October 23, 2001

Subject: Responses to August 23, 2001 NJDEP Letter and Addendum for the "Work Plan for Supplemental Investigation of Natural Attenuation of Dissolved Constituents in Groundwater", L.E. Carpenter Superfund Site, Wharton, Morris County

**PROPOSED MONITORING WELLS
AND GROUNDWATER / NATURAL ATTENUATION
SAMPLING LOCATIONS**

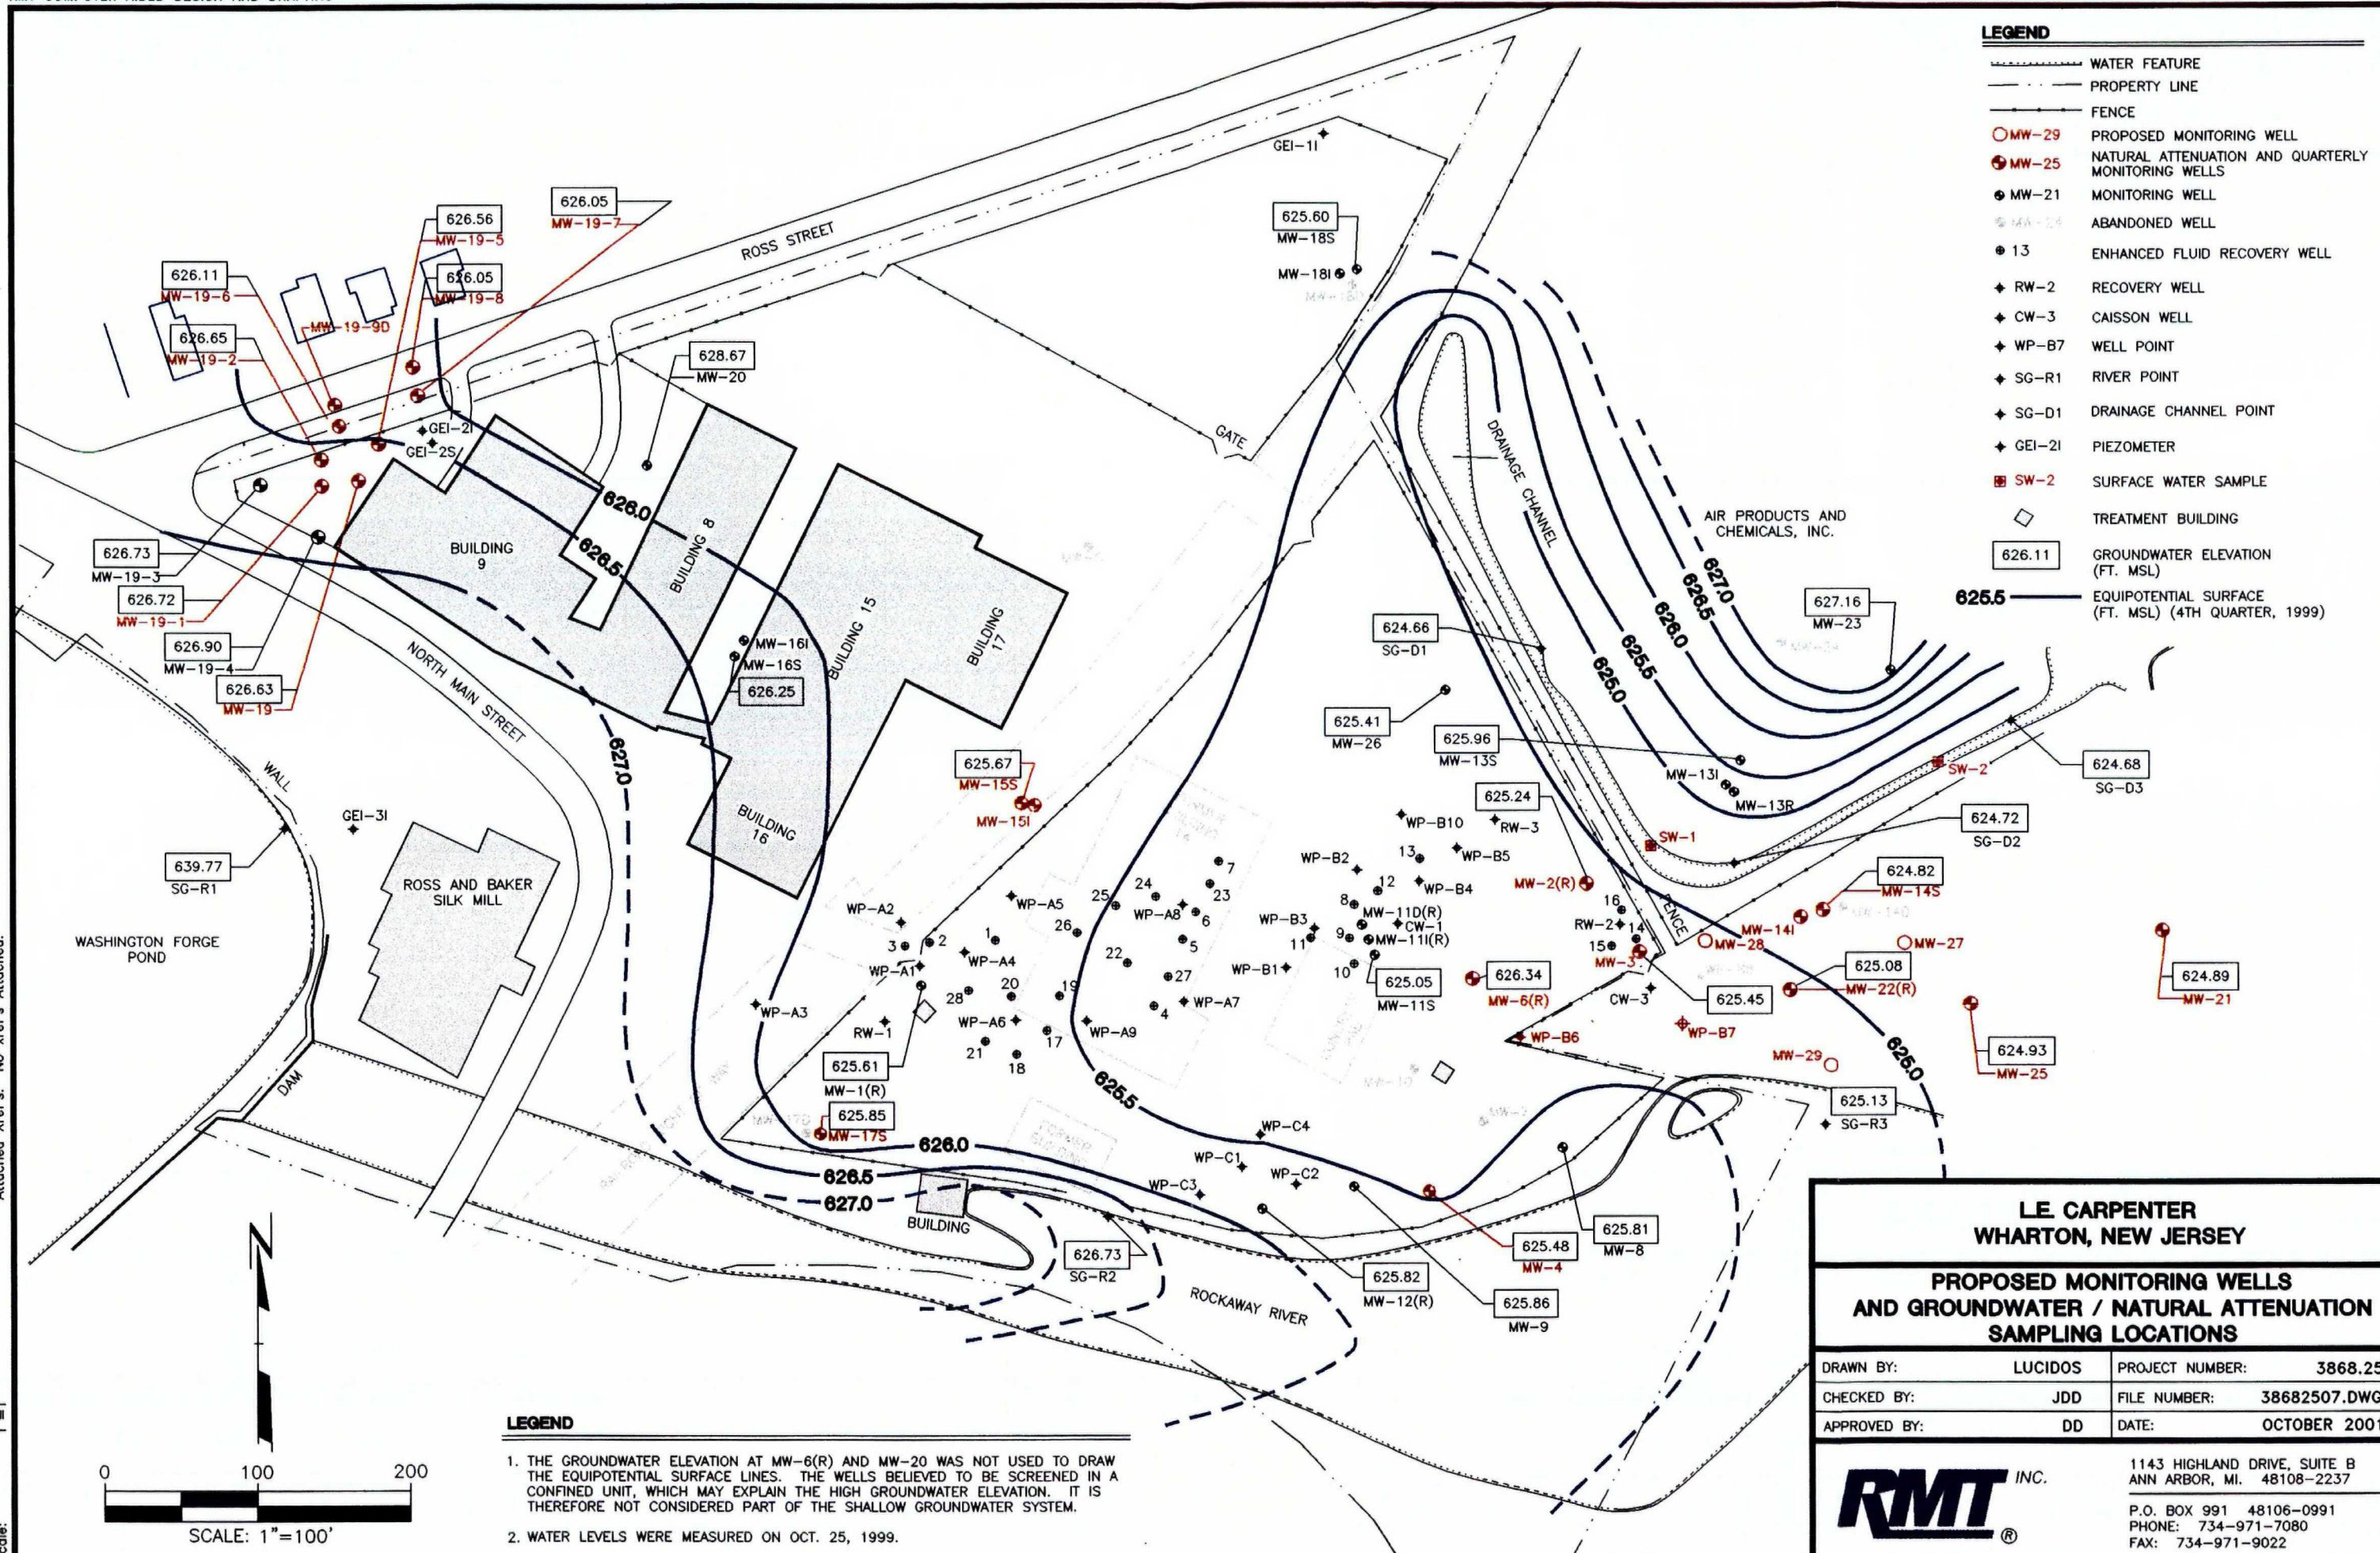
11. **Comment:** *L.E. Carpenter proposes to install two additional wells to complete plume delineation in the MW-14 area. The Department believes that the proposed well MW-28 is redundant to MW-14S and will serve no useful purpose.*

12. **Comment:** *There appears to be no advantage in locating a well between MW-3 and MW-14S. Most likely contamination will be found at MW-27 comparable to MW-22R.*

Response: RMT believes that the proposed wells are all necessary to evaluate the shallow groundwater flowpath and quality in this area in order to provide the data necessary to support the 3-dimensional model. The hydrogeology in the Wharton Enterprises area (near MW-22R) is important to quantify, because of the proximity of the two surface water bodies. Based on historical groundwater contour maps groundwater flow through the Wharton Enterprises property appears to vary significantly during different time periods. The proposed shallow well locations we show on the attached Figure 2 will allow an accurate simulation of existing conditions for the three-dimensional groundwater flow and contaminant fate and transport model.

Response: It is difficult to predict off hand what the actual concentrations in any proposed well would be given seasonal groundwater table fluctuations and apparent flow direction variations in the Wharton Enterprises area. As we described above, the rationale for locating additional wells is to fill in data gaps regarding groundwater flow patterns. These data are necessary to develop and calibrate the simulation of existing conditions for the required computer model.
